PLANNING, ZONING, & BUILDING DEPARTMENT  
PZ&B Staff Combination Memorandum: Architectural Commission and Town Council

SUBJECT: ARC-24-035 (ZON-24-043) 620 N LAKE WAY (COMBO)

MEETING: JUNE 26, 2024 ARCOM  
JULY 10, 2024 TC

PROPOSED EAST ELEVATION

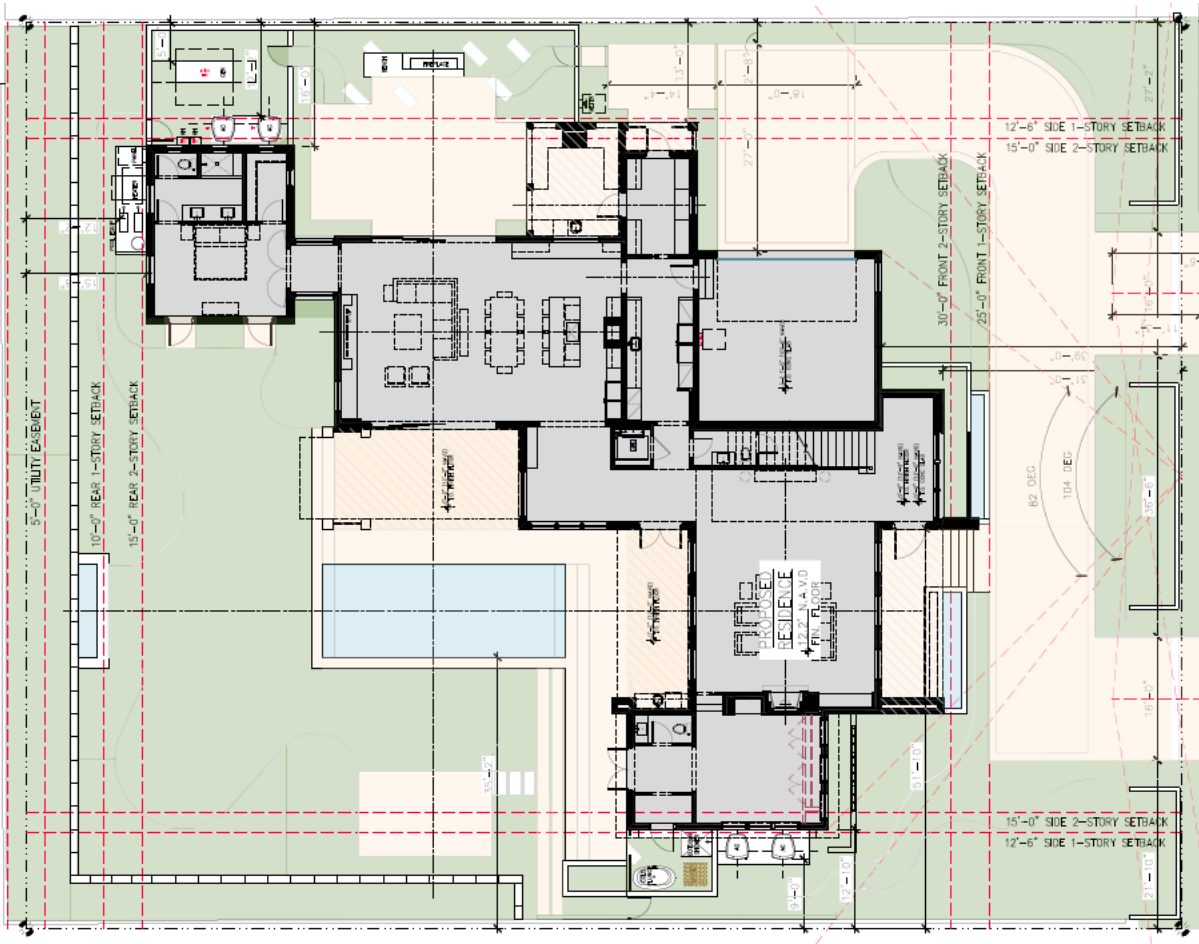
The applicant has resubmitted plans in response to commission comments received at the May ARCOM hearing. The applicant has responded with modifications to the canopy at the front entrance, modifications to the breeze block features, fenestration modifications, and a change from a hipped to flat roof at the rear bedrooms. The building layout, hardscape and landscape configuration largely remains the same from the last review.

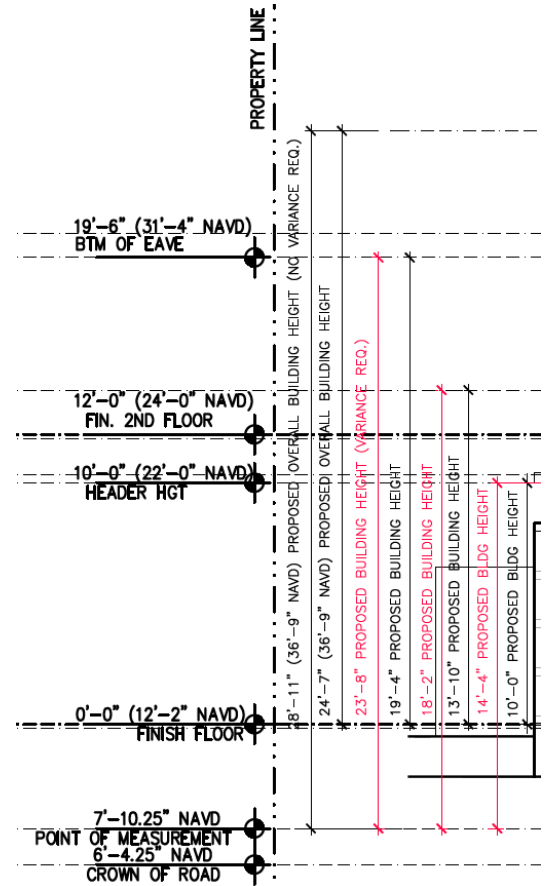
Variance 1 pertains to the proposed building height of the structure. The structure is proposed to be constructed with a building height of 23'8" where a maximum building height of 22'-0" is the maximum building height permitted. Staff will note that this is the height, as taken from the point of measurement, which is *below existing grade*. The applicant is proposing a finished floor elevation of 12.17' NAVD, and if the building height measurement was taken from this point, the building height would be 19'-4" below the 22'-0" maximum permitted.

The definition of building height clearly establishes the point of measurement at 18" above the crown of road, which does not take into account this type of parcel which experiences a somewhat significant change in grade as it traverses from the street on the east side of the parcel to the rear of the lot on the west side of the parcel. The difference in grade from the highest and lowest points on the lot are approximately 7.5'.

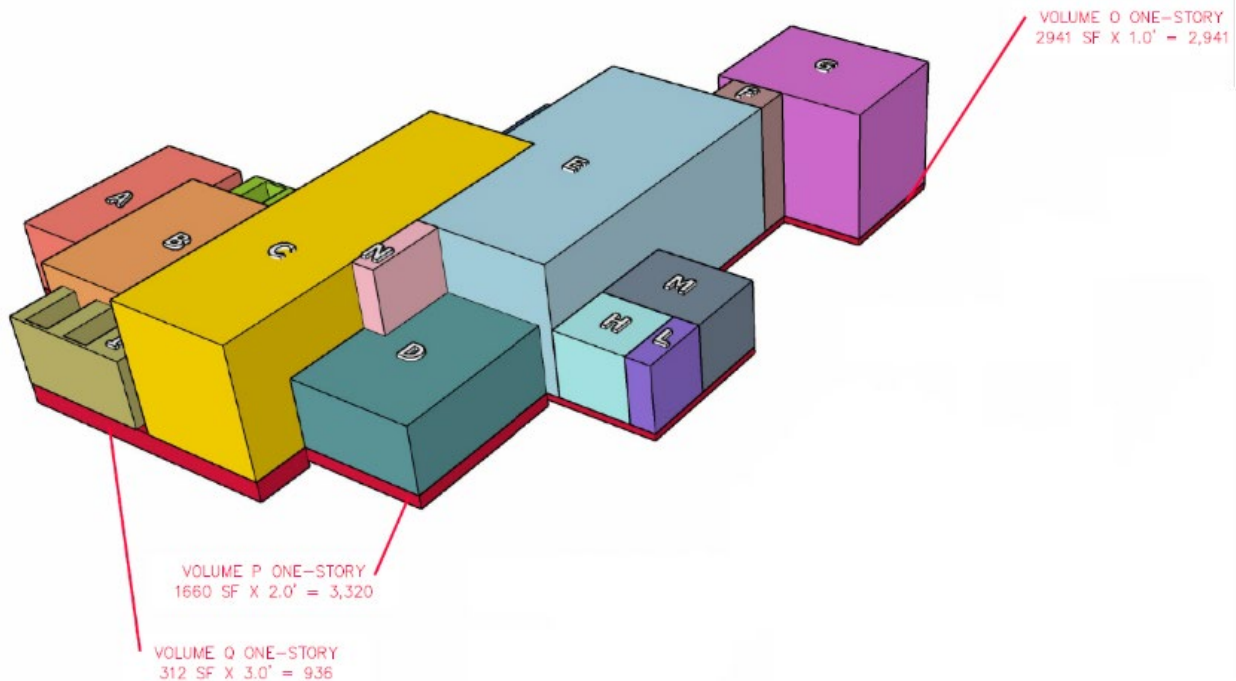
Variance 2 is to exceed the maximum cubic content ratio (CCR) permitted on site. Similar to variance 1, the lot conditions appear to be driving the variance request. Similar to the issue with building height, any portion of the structure above the point of measurement (even if it is below the

finished floor) must be included in the calculation of cubic content. If calculated from the proposed point of measurement, a variance would not be required.
